# **PLANNING COMMISSION MEETING AGENDA**

## **July 6, 2023 THURSDAY 6:00 P.M.**

The applicant, Consumers Concrete Corporation (CCC), is proposing to construct a new concrete block manufacturing plant in order to increase efficiency, reduce carbon emissions and update the appearance of the property.

**SUBJECT:** Site Plan Review #3– Consumers Concrete Corporation, 3809 E. Michigan Avenue

DRAWING NUMBER: C-7

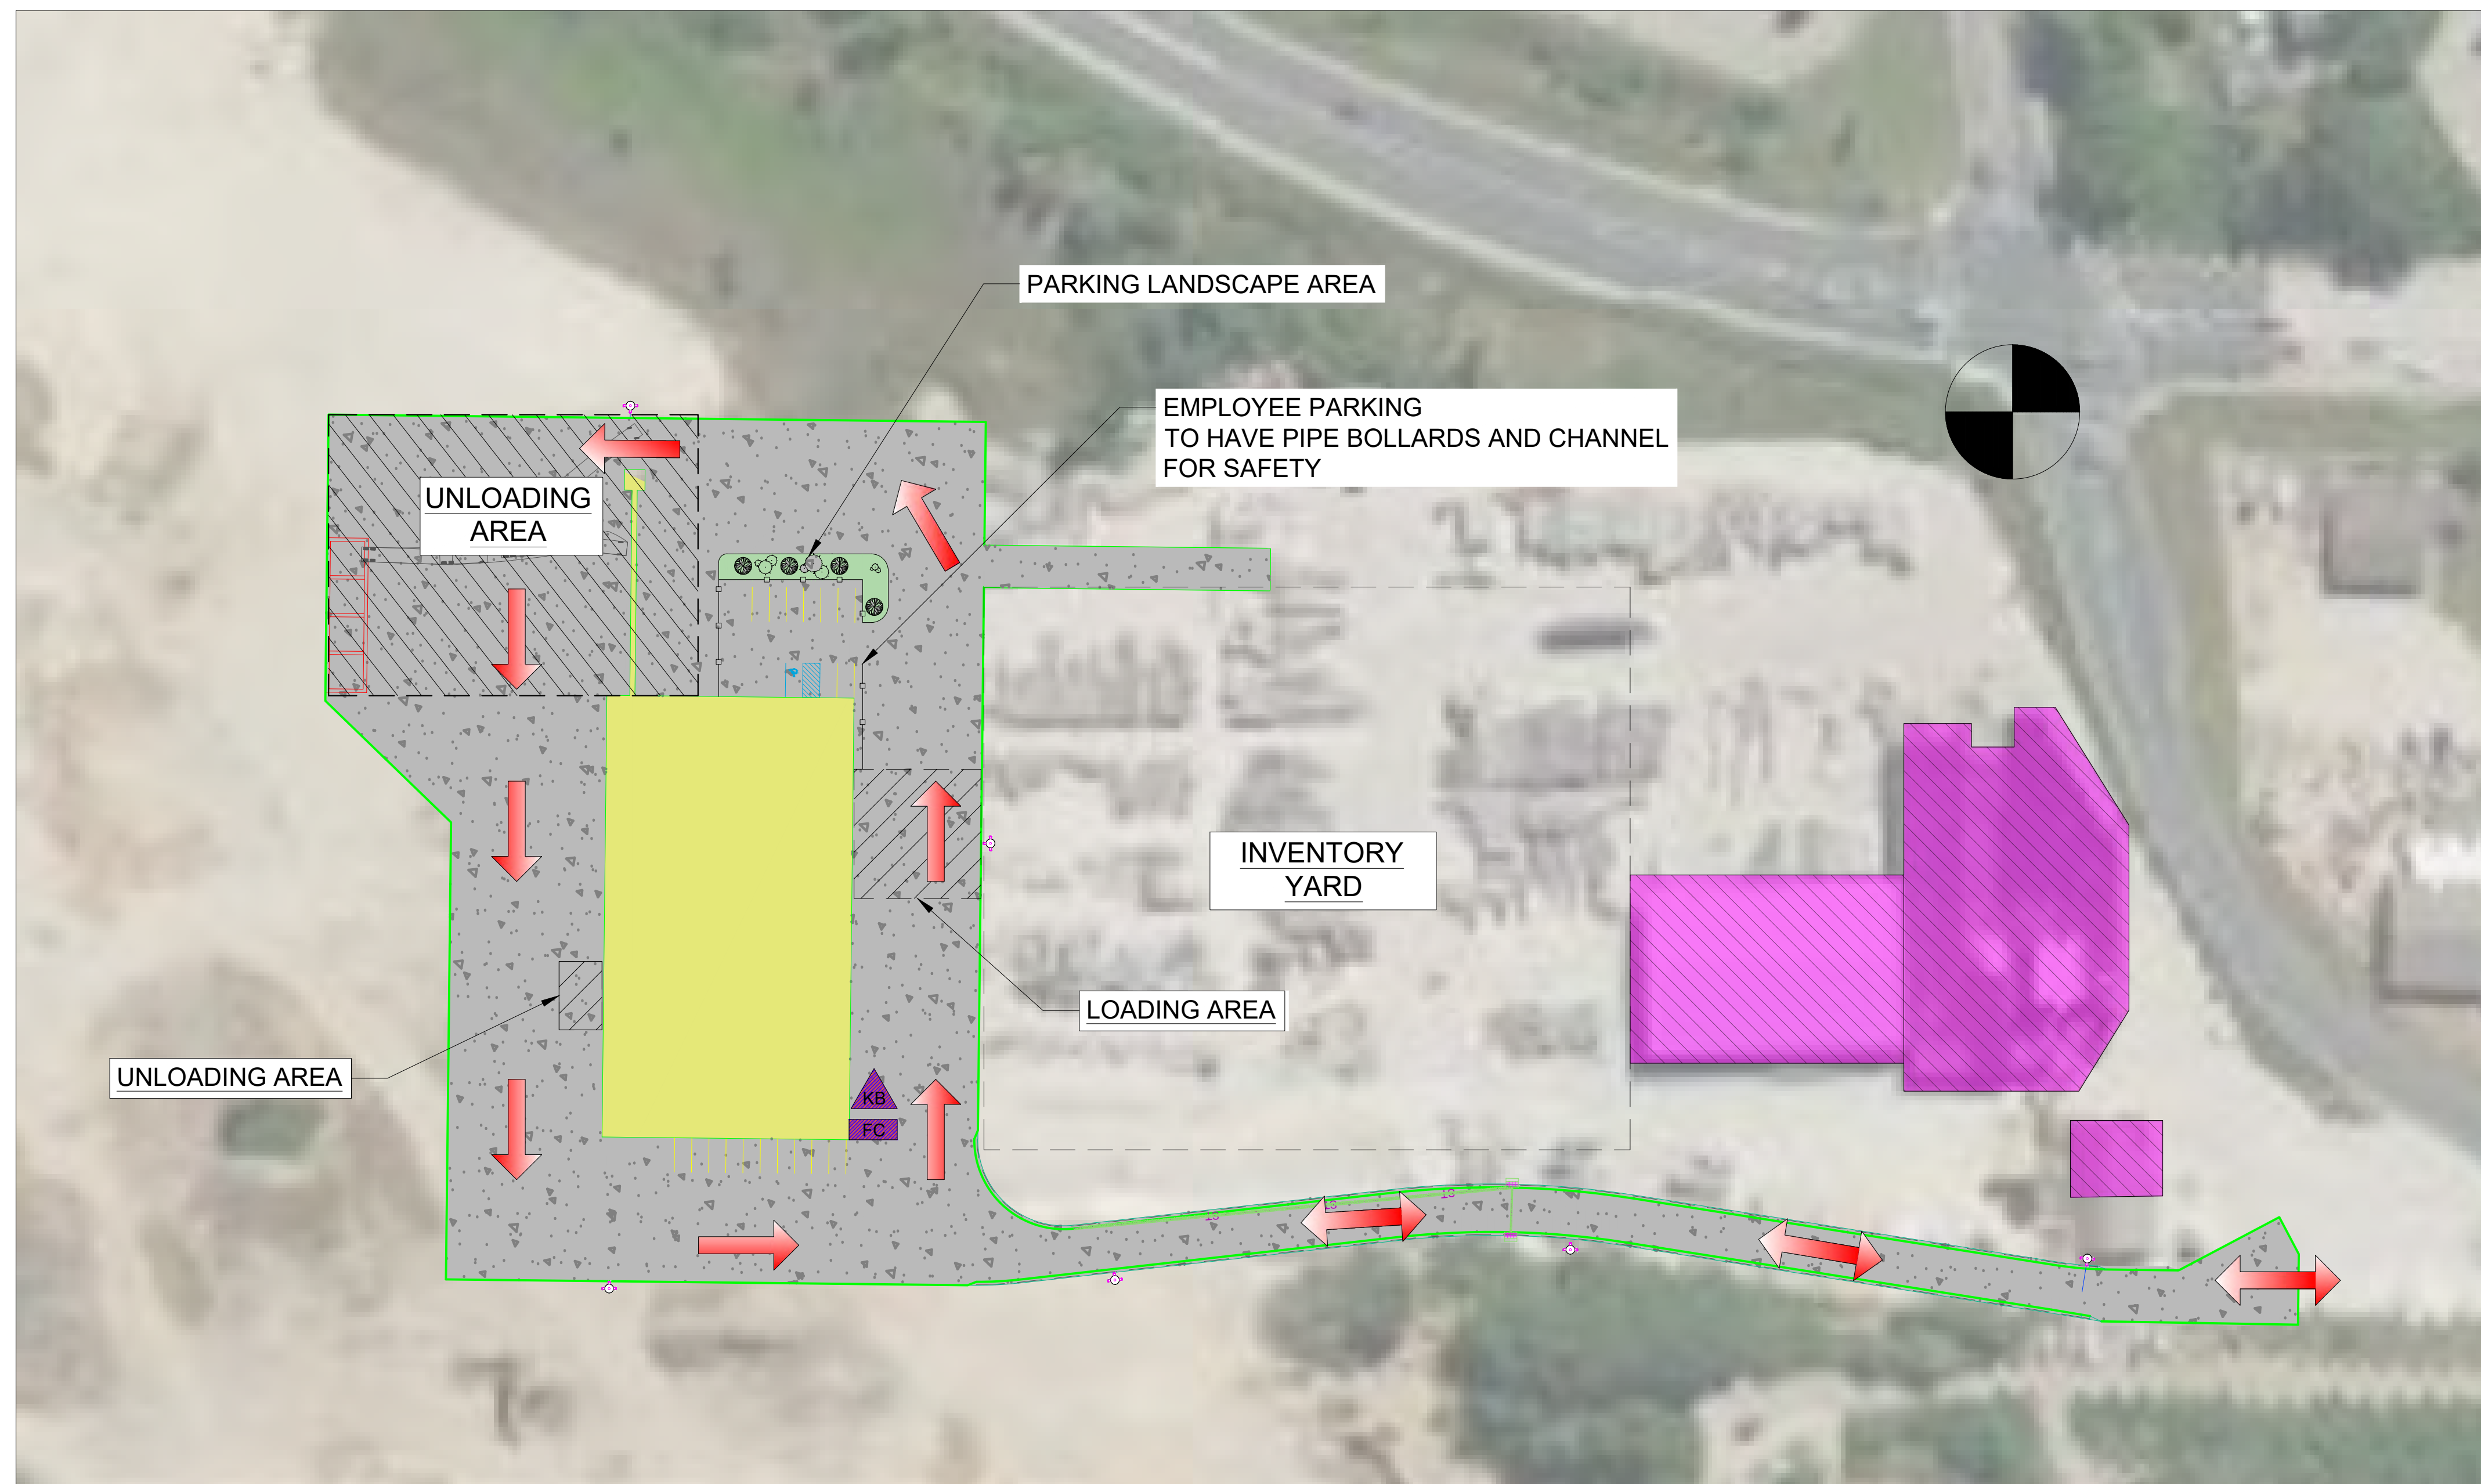
1. b. The applicant does not propose any screening around the outdoor storage areas. The outdoor storage also needs to be identified on the site plan. The subject site is mostly surrounded by parcels owned by CCC, and used for the concrete manufacturing operation; however, screening along parcels not owned by CCC and along E. Michigan Ave. should be present. Streetview images appear that

Response: On drawing C-7 we indicate "Inventory Yard" and "Unloading Area" which are the outdoor storage areas. The east side of these areas are bordered by a natural landscaped strip along Sprinkle Road. There were no plans to add trees or landscape to the existing landscape. If preferred, Consumers can add a variety of native trees along this space, however that space is in Comstock Township.

DRAWING NUMBER: C-3

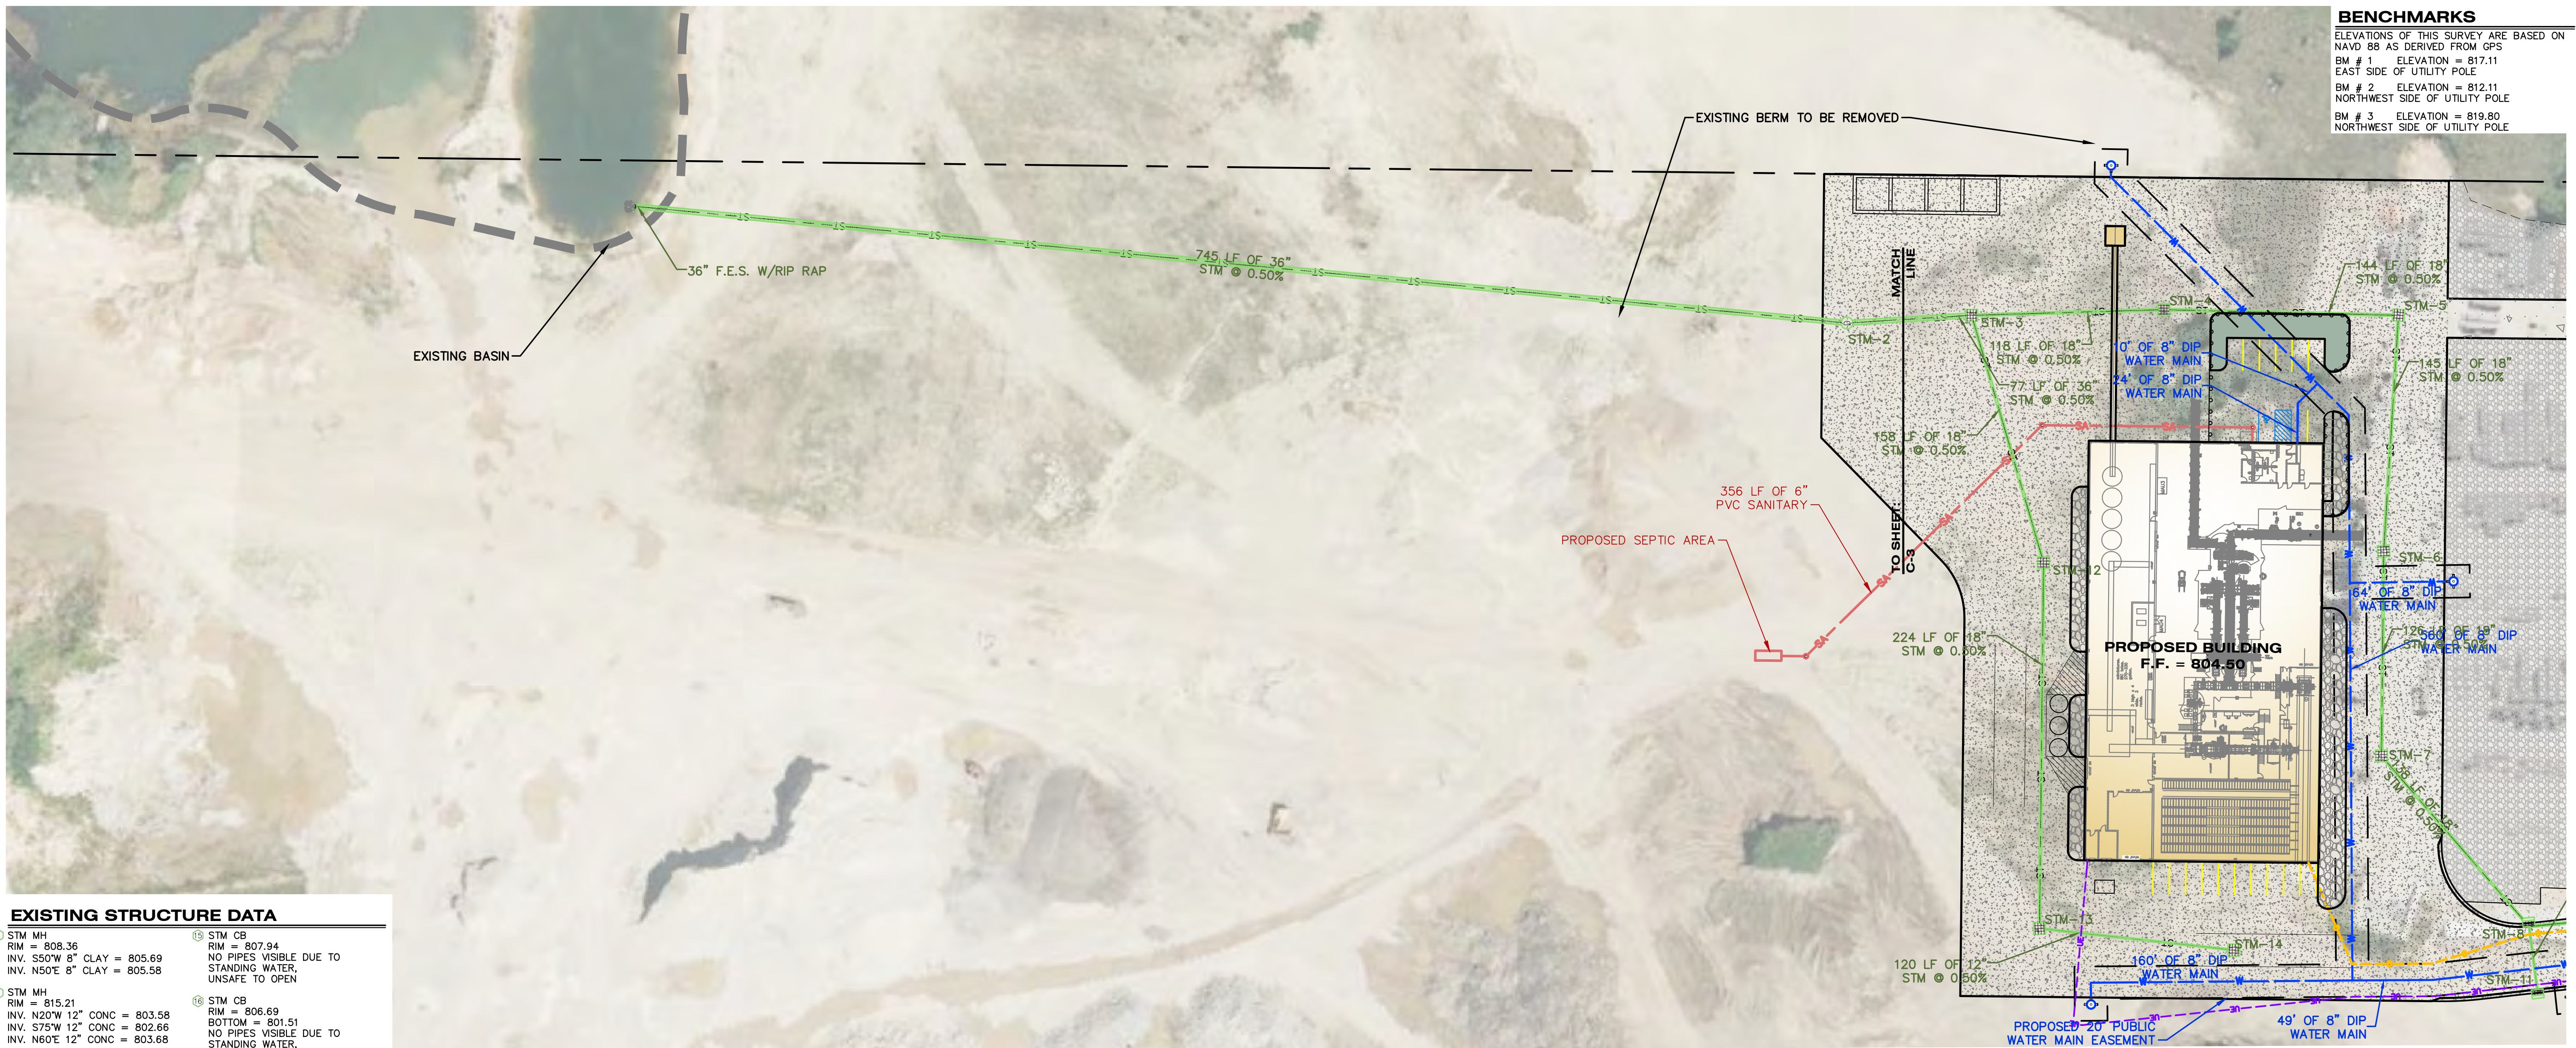
The site plan does not show drainage patterns but does indicate the presence of storm water retention on adjacent parcels owned by CCC. Stormwater from the project will drain to a dredge about 1,100 feet northeast of the plant. Stormwater plans are subject to review by the Township Engineer.

Response: New area collected stormwater is planned to be routed to the existing on-site pond. Stormwater elements are shown on drawing C-3 and C-9.
